City Planning Commission  
Sacramento, California

SUBJECT: Review of Final Landscape and Irrigation Plans for the Mercy Hospital  
Parking structure (P82-195)

BACKGROUND INFORMATION: On June 6, 1983 the Planning Commission approved a special permit to develop a multi-story, 800± space parking structure, subject to conditions. One of these conditions required Commission review of final landscape and irrigation plans prior to final inspection of the parking structure. The subject report is presented to satisfy this condition.

# Exhibit B-1

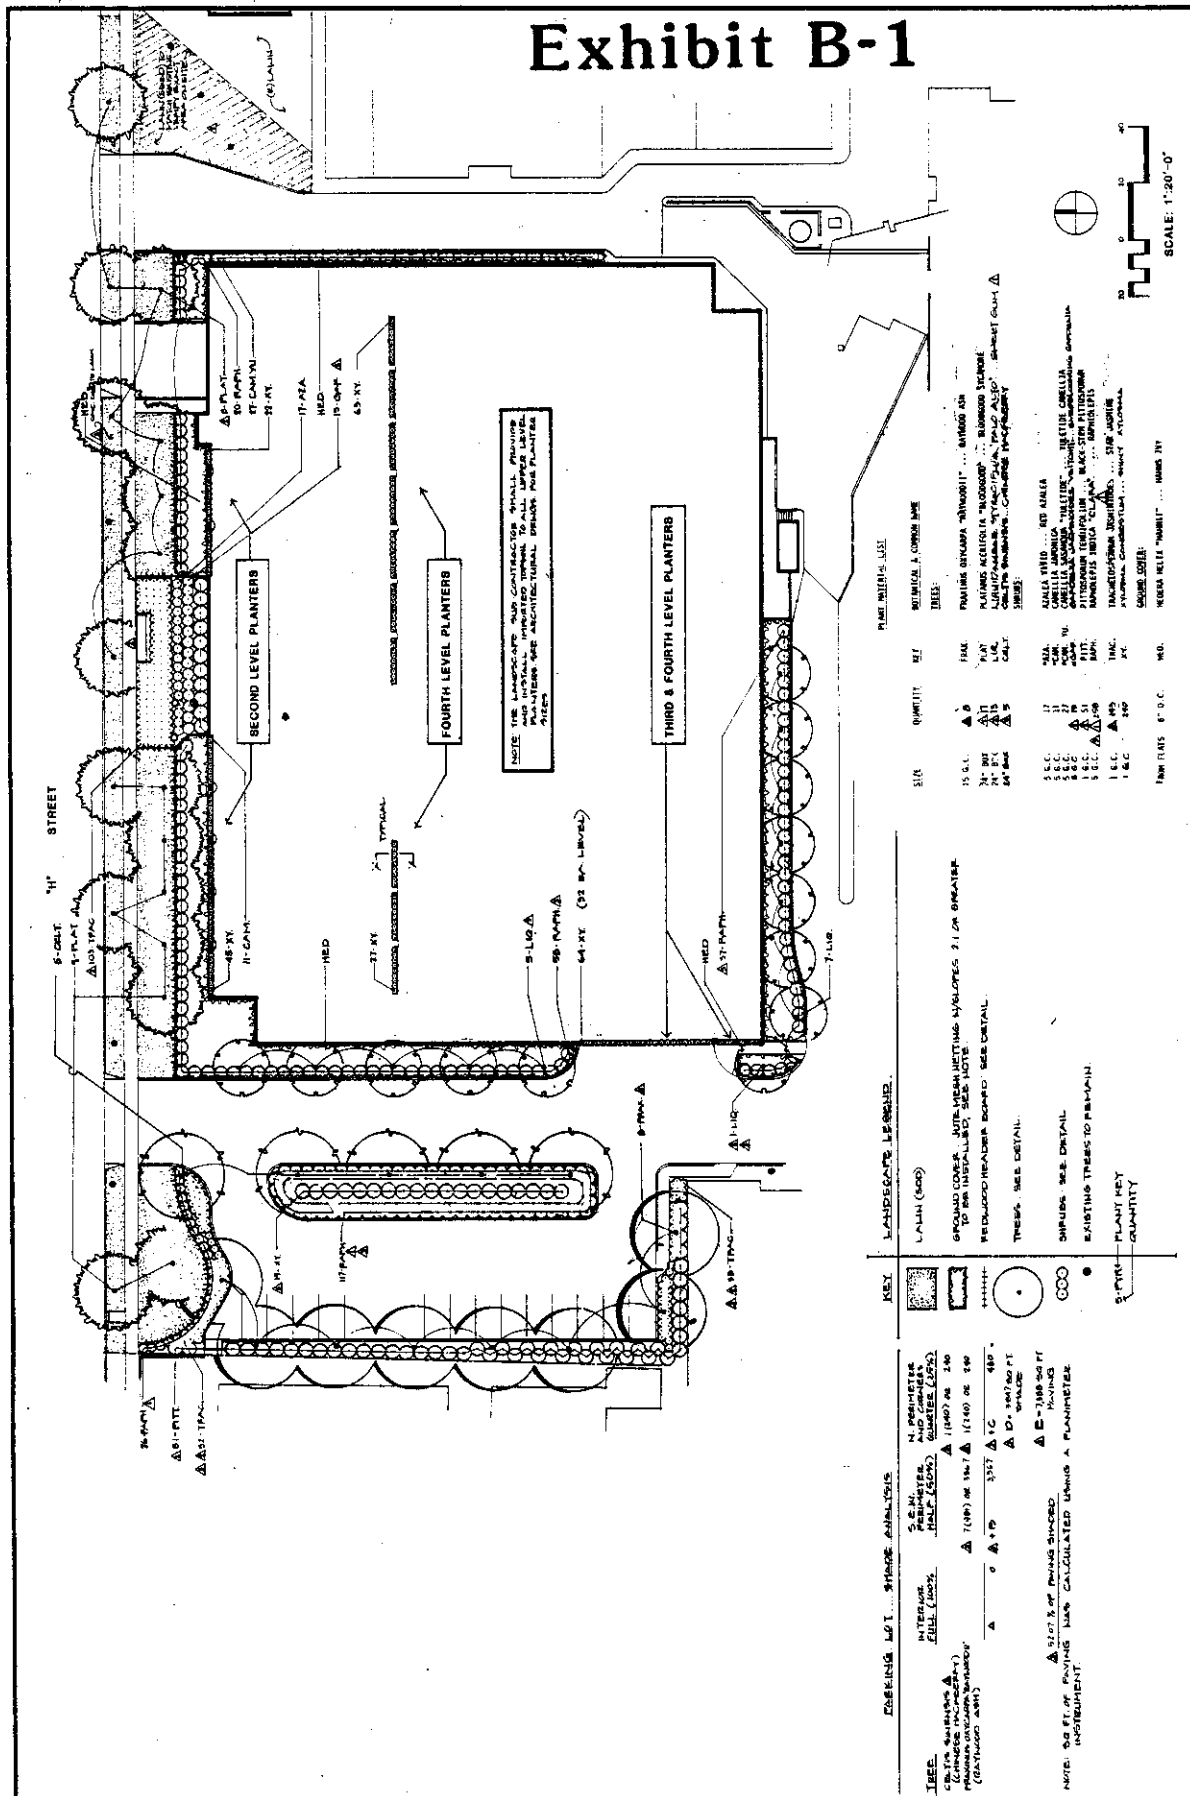
STAFF EVALUATION: The project plans initially submitted with the EIR and special permit are attached and marked as Exhibit A-1-4. The current plans reflected in the building permit are attached and marked as Exhibit B1-2. In general, staff finds the plans consistent with the Commission's expressed concerns.

STAFF RECOMMENDATION: The staff recommends that the Commission approve the attached plans.
